APPLICATION NO: 24/01435/FUL	OFFICER: Ms Michelle Payne
DATE REGISTERED: 31st August 2024	DATE OF EXPIRY : 26th October 2024
WARD: Charlton Park	PARISH: CHARLK
APPLICANT:	East Gloucestershire Club
LOCATION:	East Gloucestershire Club Old Bath Road Cheltenham
PROPOSAL:	New fabric canopy over existing 3no. padel courts, construction of 4no. new outdoor padel courts inclusive of floodlighting in place of 1no. grass tennis court, and associated circulation space.

REPRESENTATIONS

Screenshot of proposed elevations from planning submission

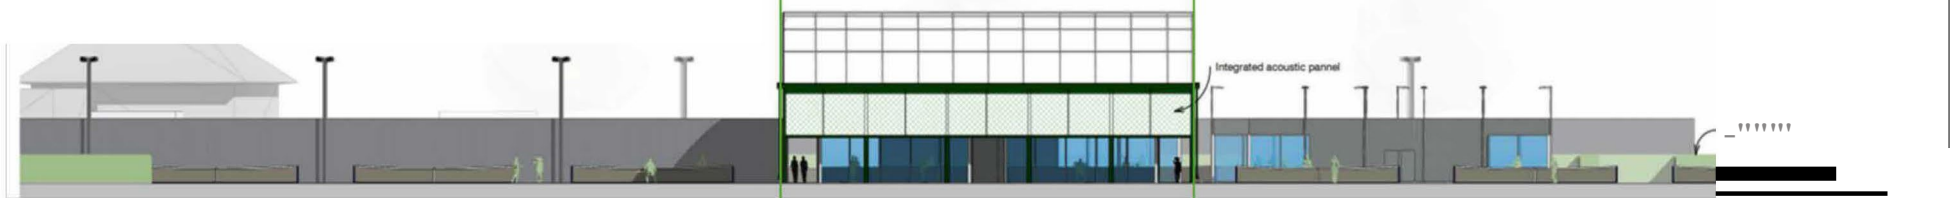
Green lines show alignment of existing padel courts width to demonstrate accuracy of overlay

Overlay of proposed elevations from planning submission

Figure 2 Padel Court Layouts

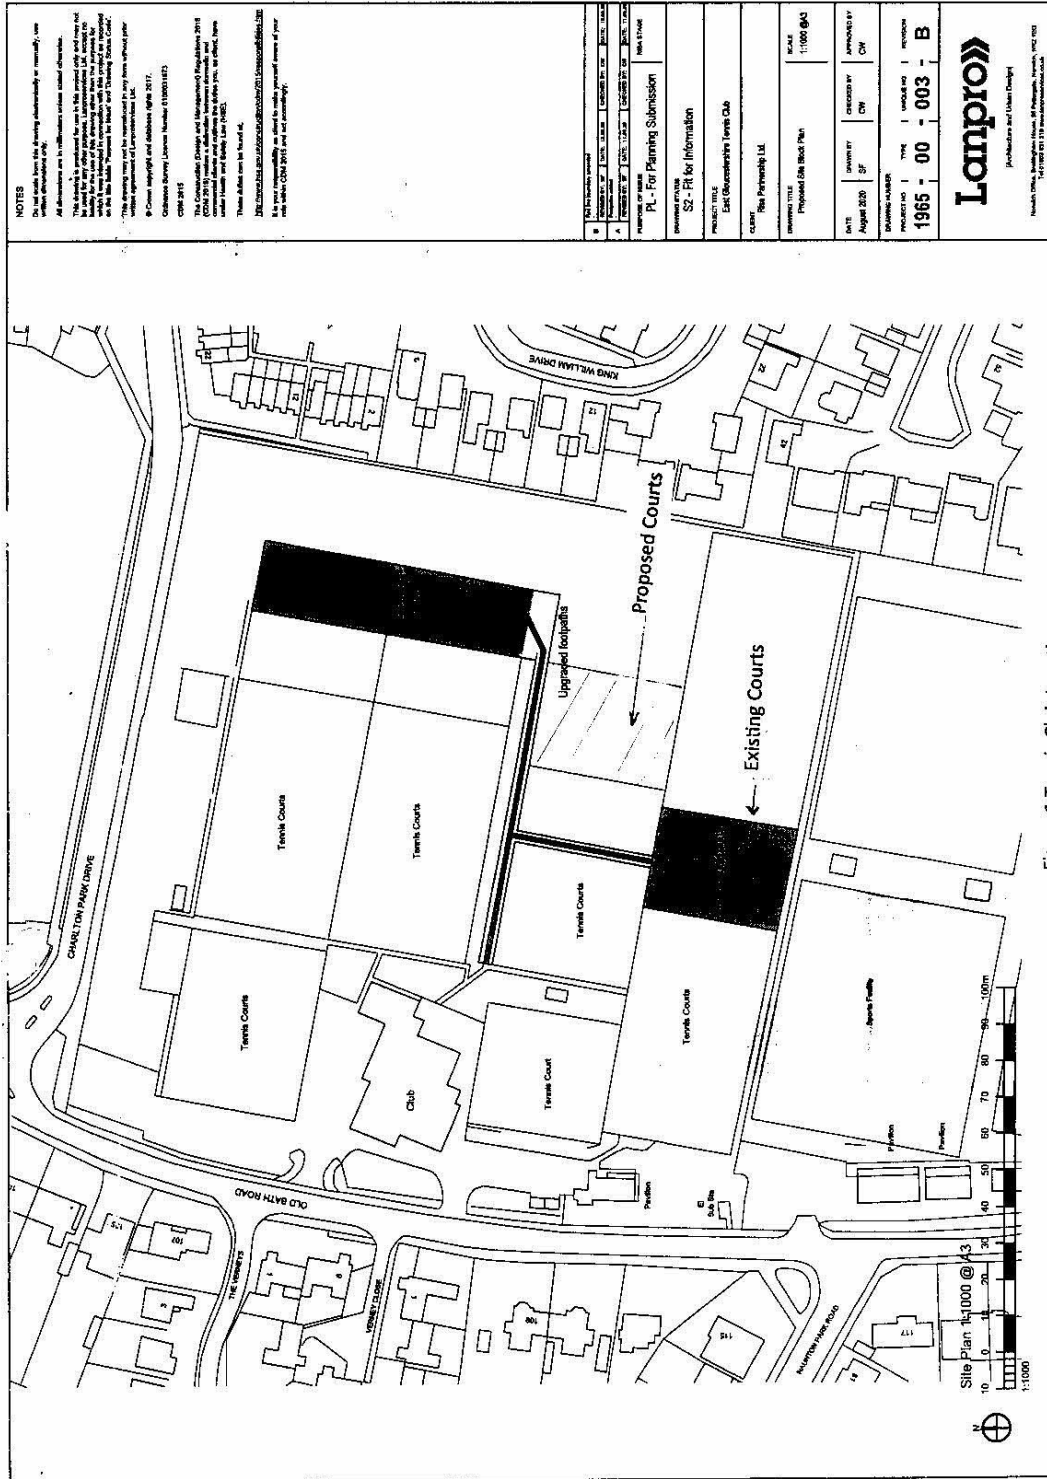
The East Gloucester Club at Old Bath Road, Cheltenham has large number of tennis courts plus a club house, car park and a separate croquet facility. Figure 1 shows the area occupied by the 3 existing padel courts and the area proposed for the 4 new padel courts. Both areas lie approximately in the centre of the tennis club complex. The existing 3 court layout consists of 2 padel courts parallel to each other with the third court at right angles, as shown in figure 2

Figure 2 also shows the proposed 4 court layout with 3 padel courts parallel to each other and the fourth smaller court at right angles. It is understood that the smaller court is for singles games, whilst the larger courts are for doubles games.

Figure 3 Location of Measurement Positions

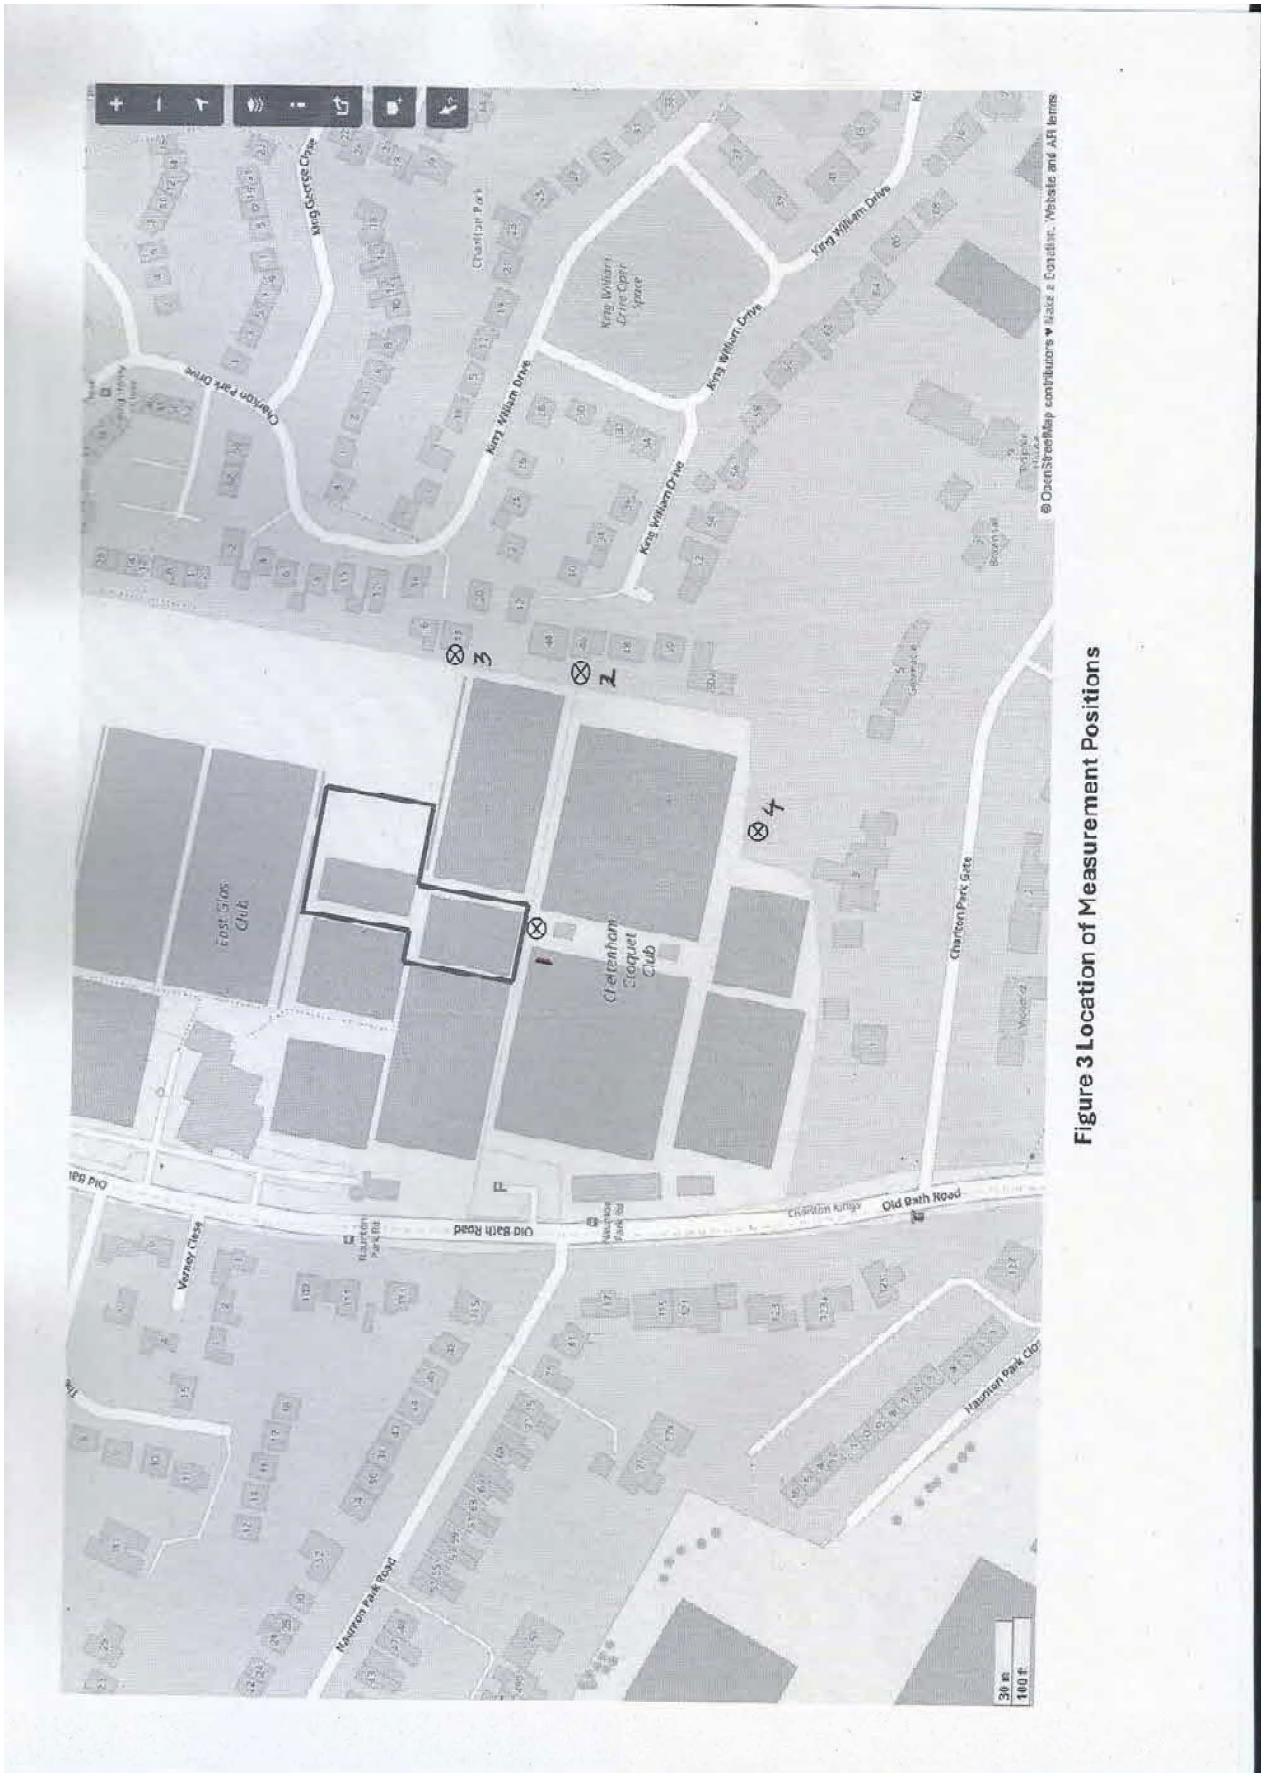
Four freefield measurement positions were selected as shown in figure 3, with position 1 next to the padel courts, positions 2 and 3 in the rear gardens of 46 King William Drive and 18 King William Drive, and position 4 in the rear garden of Grey Gables, Charlton Park Gate. Again it was not possible to observe the court activity owing to intervening hedges or long distances, but the padel tennis was clearly audible at all 4 locations. The rear boundary of 46 King William Drive had a Leylandii hedge, but no timber fence. 18 King William Drive also had a Leylandii hedge, plus a 2m high timber fence. The rear boundary of Grey Gables was covered in trees and hedges, but no timber fence.

The text for the 24 hour session refers to 2 measurement positions and the Appendix 1 tables provide the results for 2 positions, but the text above figure 3 only mentions one position close to the nearest noise sensitive receptor. This appears to be position P2 in figure 3, but the text immediately above figure 3 refers to position P1 only. Again the positions are labelled P1 and P2, and only one 3m high pole is mentioned in the text on page 8. On the other hand the photographs on pages 10 and 11 show 4 sound level meters with 2 sound level meters at 3m height and 2 meters at 1.5m height, but again the captions to the diagrams suggest 3 attended positions and one unattended position.

A closer inspection of table 4 shows that the position numbers or position locations need reversing, since one would normally expect the noise to the side of the court to be higher than the noise at the end of the court; i.e position 1 to the side of the court and position 2 to the rear of the court as per figure 4.

Figure 3 Plots of LAeq
The red lines are the stated means during Padel operating hours

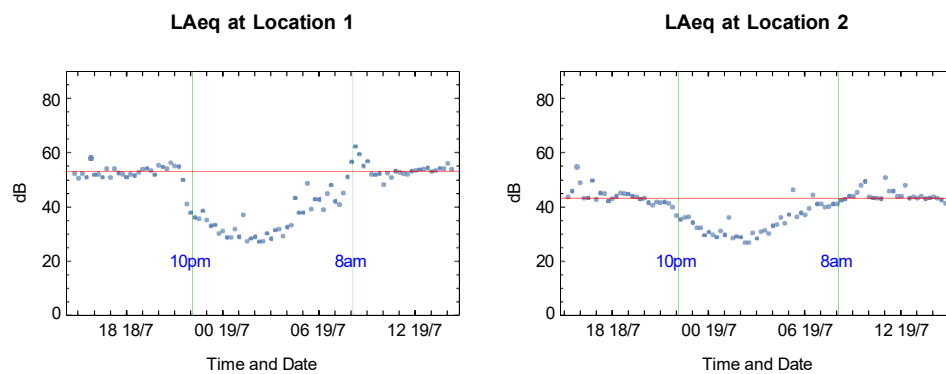
- 3.2.1. This contradicts section C.2.9.b of the Cheltenham Plan (2020) to “*conserve, manage and enhance Cheltenham’s natural environment and biodiversity*” and to **protect greenspaces** (16.3), which contribute “*to the health and well-being of residents and visitors. In addition, green spaces add to the quality of the town’s built and natural environment*” (16.1).

- 3.2.2. Indeed Section 5.18 of the Plan notes that “*a considerable amount of green space in Cheltenham is owned privately. It can take the form of playing fields and the gardens / grounds of commercial, educational and domestic properties. The environmental value of such green space can equal that of publicly owned green space but it is often overlooked*”. Policy D3 (private green space) states that “***The development of private green areas, private open spaces and private gardens which make a significant contribution to the townscape and environmental quality of Cheltenham will not be permitted***”, yet this proposal seems to be a **prime example of valuable green space being irrevocably harmed.**

Figure 4 Plots of LAFmax

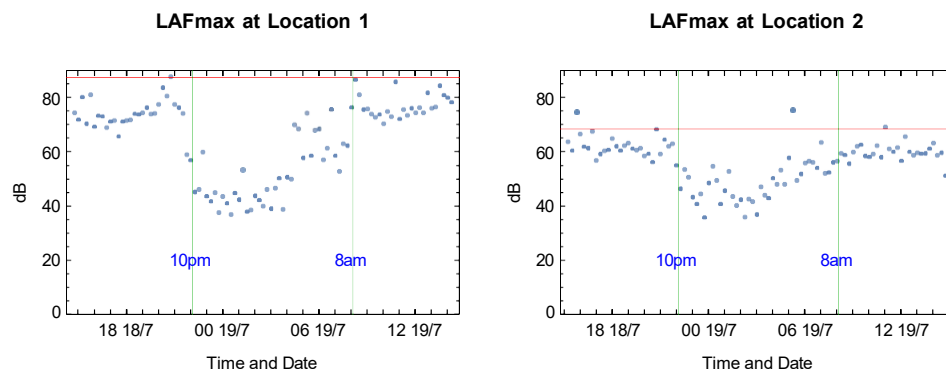
The red lines are the stated maxima during Padel operating hours. Note there appears to be an error in that for location 2, the level of 75.1 on 18/7/2024 at 15:45 has been accidentally omitted.

Screenshot of REVISED proposed elevations from planning submission (South elevation)

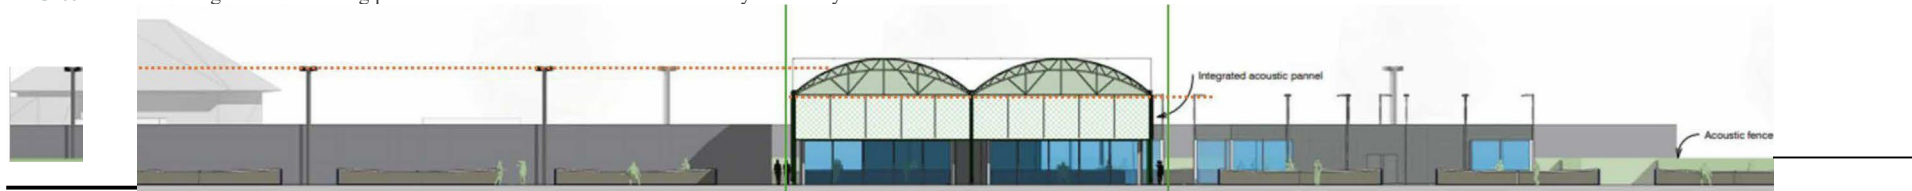
- a. The revised canopy design fails to address the concerns raised by myself and many others, including the Cheltenham Architect Panel, the Croquet Club, and the Cheltenham Civic Society.

- b. The designs would still be visually overbearing at 8.5m tall and, given the expanse and brightness, much more visually intrusive than floodlights of comparable height. It would remain highly visible from the surrounding properties and public realms and **highly out of keeping with the character of the surrounding neighbourhoods, the College Character Area and the wider Cheltenham Central Conservation Area**, within which East Glos sits.

Green lines show alignment of existing padel courts width to demonstrate accuracy of overlay

Overlay of REVISED proposed elevations from planning submission
